Access Compliance Report

Public Rights-of-Way

(Curb Ramps)

Intersection ID: 6799	Main Street: KNEIGHTON_LN	Cross Street: W_SUGAR_CREEK_RD	Location: SE
ADA ID: E31E029FC549	Ramp Type: PerpDiag	Initial Pass/Fail: Fail	Overall Compliance: No
Severity Score: 13.75			
Codes/Mitigation Info/Possible Solution		Field Measurements/Component Compliance

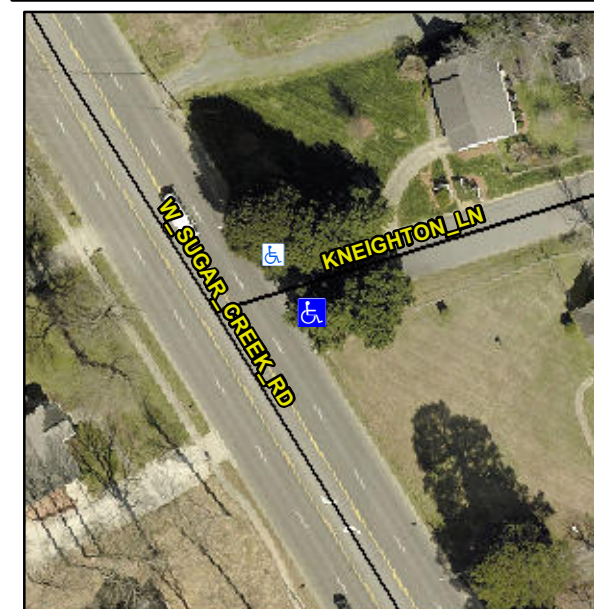
Not Found, R304.2.2, R304.5.3

Compliance	Description	Data	Compliance	Description	Data
N/A	Ramp Length (in)	65.5	No	Ramp Slope (%)	11.5
Yes	Ramp Width (in)	53.5	No	Ramp XSlope (%)	4.7
N/A	Flare Type LT	N/A	N/A	Flare Type RT	N/A
N/A	Flare Slope LT (%)	N/A	N/A	Flare Slope RT (%)	N/A
N/A	Flare Traversable LT?	N/A	N/A	Flare Traversable RT?	N/A
N/A	Landing Length (in)	N/A	N/A	DWS Provided?	N/A
N/A	Landing Width (in)	N/A	N/A	DWS Contrast?	N/A
N/A	Landing Slope (%)	N/A	N/A	DWS Length (in)	N/A
N/A	Landing X Slope (%)	N/A	N/A	DWS Full Width?	N/A
N/A	Landing Curb? (Y/N)	N/A	N/A	DWS Offset (in)	N/A
N/A	Shared Landing?	N/A			
N/A	Gutter Ponding?	N/A	N/A	Gutter Slope (%)	N/A
N/A	Gutter Lip Ht (in)	N/A	N/A	Gutter X Slope (%)	N/A
N/A	Painted X Walk1?	No	N/A	Painted X Walk2?	No
	X Walk 1 Direction	To N		X Walk 2 Direction	To W
N/A	X Walk 1 Width (in)	N/A	N/A	X Walk 2 Width (in)	N/A
	X Walk 1 Slope (%)	3.8		X Walk 2 Slope (%)	3.8
	X Walk 1 X Slope (%)	5.1		X Walk 2 X Slope (%)	5.1

Remove & Replace Curb Ramp With Two New Directional Ramps or Equivalent.
